Rezoning Transportation Analysis
Petition Number: Insert Zoning Petition #2021-018
General Location Identifier: Tax ID 07908301

From: Robyn Byers, Ph.D.
 Robyn.Byers@ci.charlotte.nc.us
 704-336-7404

Reviewer: Eric Lemieux, PE
 Eric.Lemieux@charlottenc.gov
 704-336-2683

Date	Description
02-25-21	First Review (EL)
03-25-21	Second Review (KP)
04-27-21	Third Review (EL)

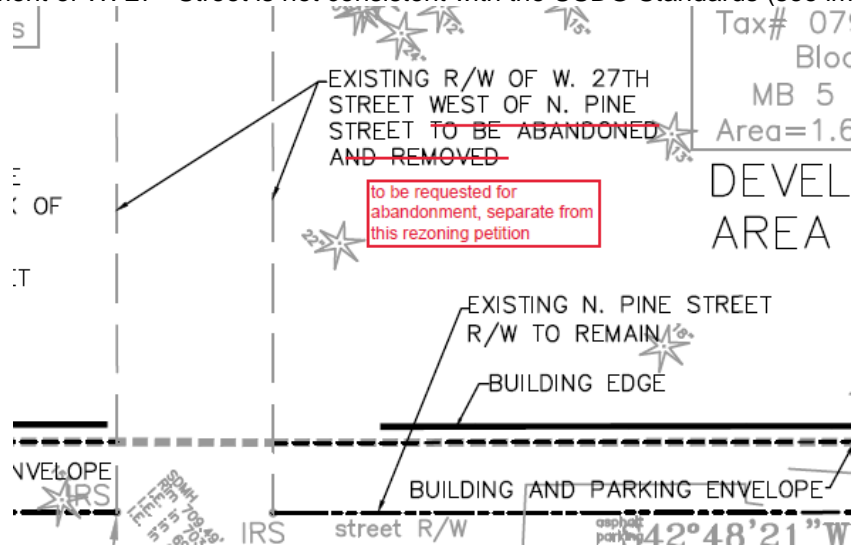
7. On sheets RZ-1 and RZ-2, remove call-out to abandon and remove W. 27th Street. Also, remove the site conditional note 3. Access, Buffers, Screening, Open Space and Pedestrian Circulation, Note I. The abandonment of W. 27th Street is not consistent with the USDG Standards (see image below).

Update to Comment as a Result of 03/16/2021 Site Plan: Remove note 3.K. This is covered in the site plan call-out, and is a separate process from the rezoning.
